Service Letter No. 345

SUBJECT: Hartzell Service Bulletin No. 75 - Inspection of Hartzell Governor for Presence of Vent Hole

MODELS AFFECTED: PA-23-250 Aztecs and
PA-24-250 Comanches - Equipped with Hartzell Model B4
Governors

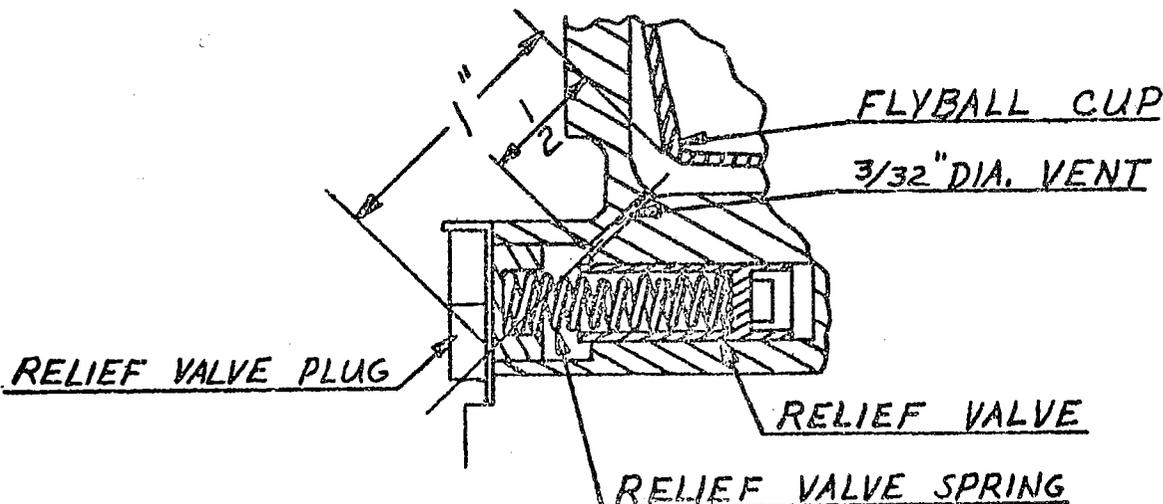
DISCUSSION: There have been several instances reported wherein excessive governor pressure ruptured the piston of the propeller. In every instance, this occurred during engine run up, when the oil was relatively cold and thick. Investigation of the Hamilton-Standard governor, modified to Hartzell specifications, revealed that a vent hole in the governor body was missing or plugged. This vent hole, which connects the spring side of the relief valve cavity with the flyball housing, prevents oil from locking the relief valve in the closed position. Governor bodies of certain model Hamilton-Standard governors do not have this vent present.

1. Remove relief valve plug cap and spring, on side of governor.
2. Check visually for presence of open vent hole, as shown on sketch below:
 - (a) If vent hole is not present, drill one as described below.
 - (b) If vent hole is present, check to be sure it is open to the flyball housing. Use length of safety wire and insert it into the hole for the distance shown if possible. If vent is plugged, the wire cannot be inserted the full distance.
3. If vent hole is absent or plugged:
 - (a) Remove governor from engine
 - (b) Remove governor cap
 - (c) Remove plug, or drill vent as shown.

CAUTION!! Great care must be taken to insure that chips do not enter governor passages. Clean thoroughly.

4. Reassemble governor and reinstall on airplane.
